RHODES

PLANNING REVIEW

John Toon Pty Ltd

30th November 2009

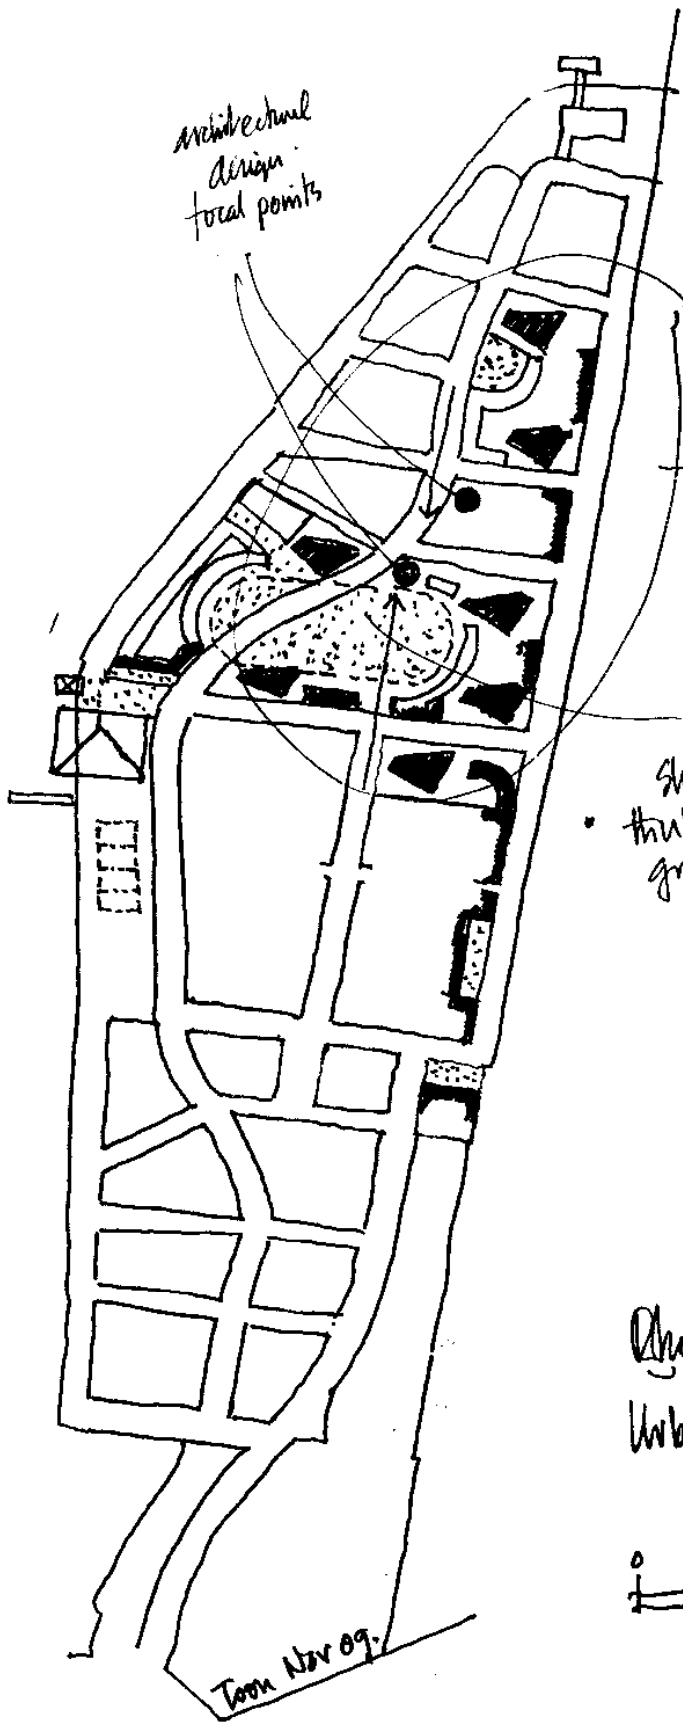
cluster of houses

Rhodes
Views + vistas
+ main elements

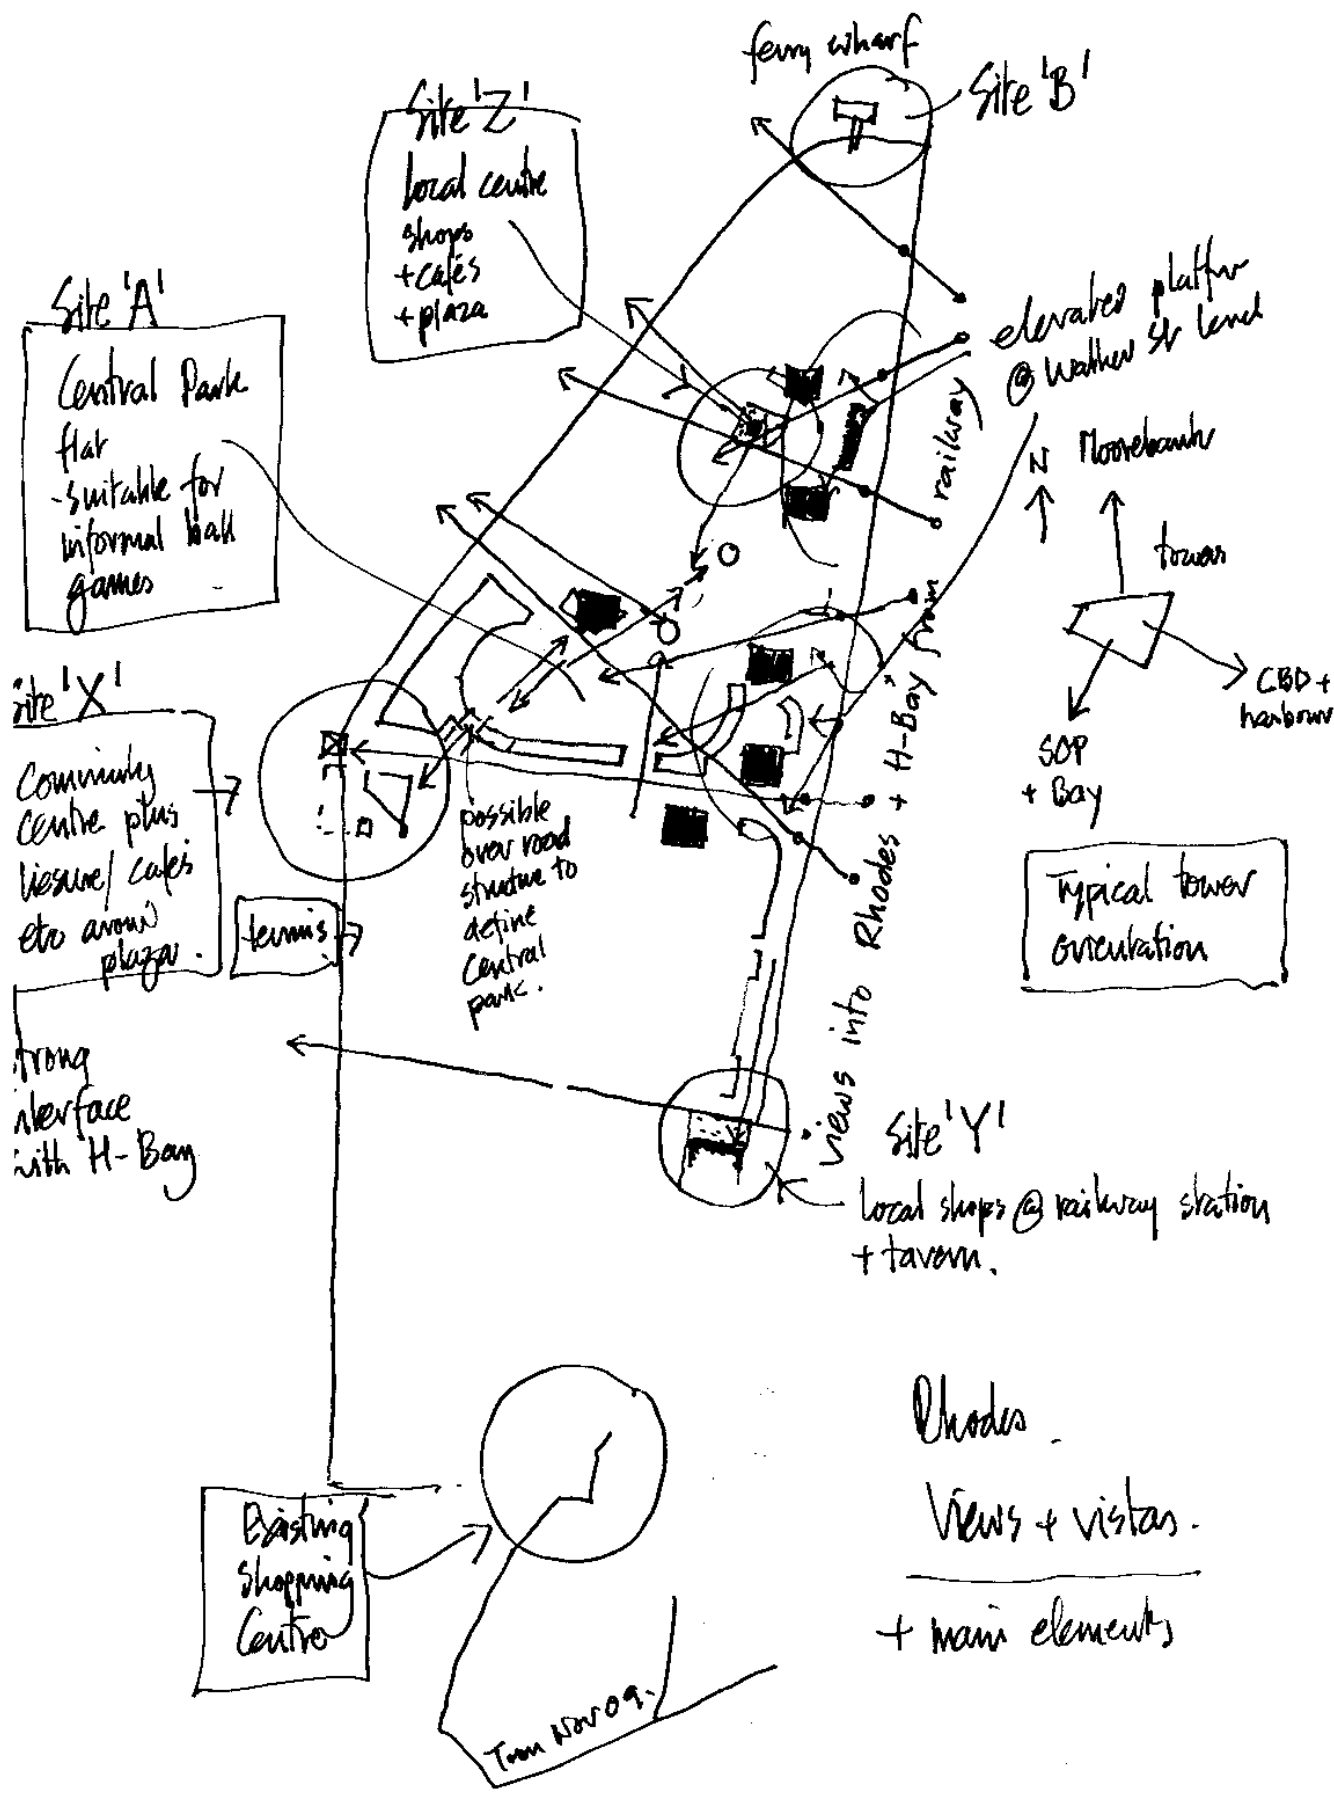
architectural design focal points

cluster of houses in this area.

Central Park (allow Shoreline Drive to flow thru' the parkland - open grassland for active ball games
hurler regular pitches.
